### Figure 3.4.11-1 NINE MILE POINT UNIT 2 NON-CRITICAL HYDROTEST

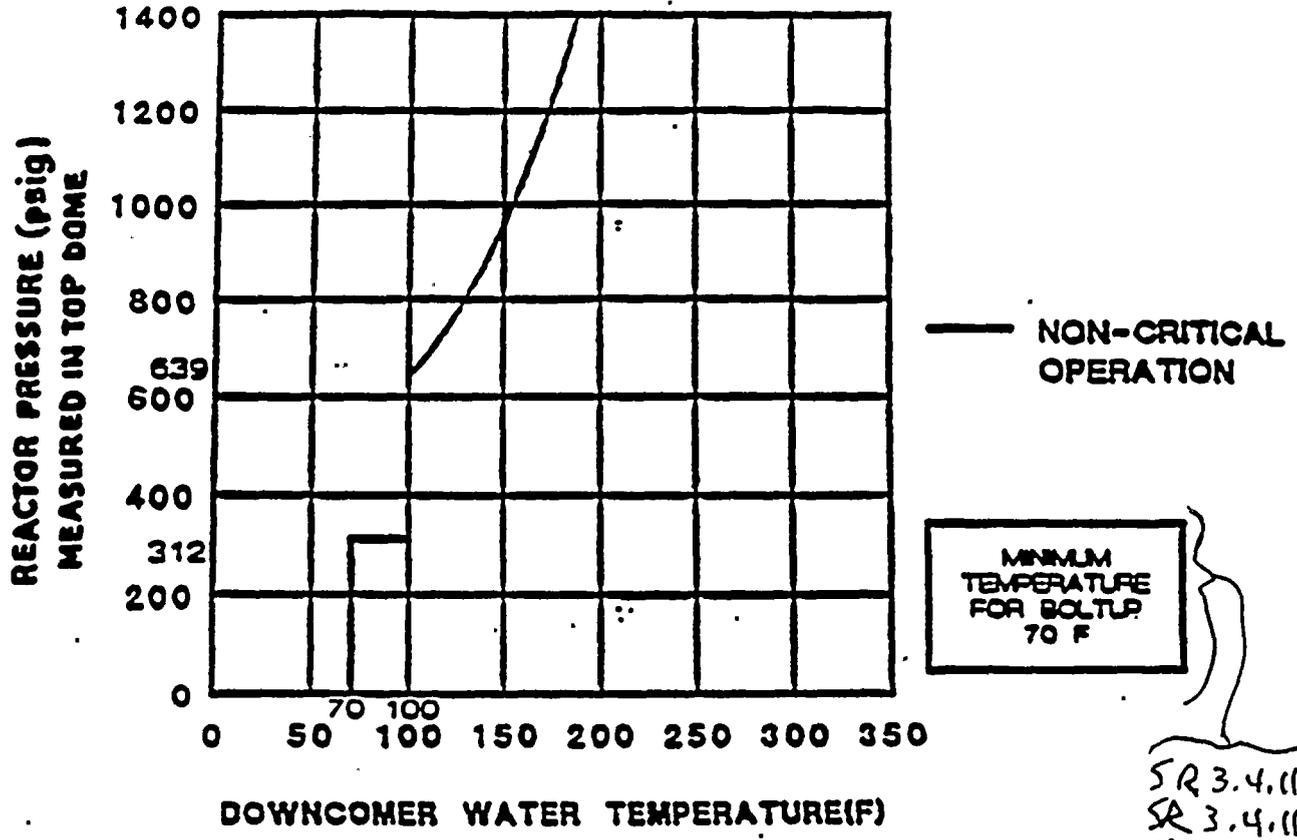
FIGURE 3.4.6.1-1 MINIMUM BELTLINE DOWNCOMER WATER TEMPERATURE FOR PRESSURIZATION DURING HYDROSTATIC TESTING AND SYSTEM LEAKAGE TESTING (REACTOR NOT CRITICAL) FOR UP TO 12.8 EFFECTIVE FULL POWER YEARS OF OPERATION
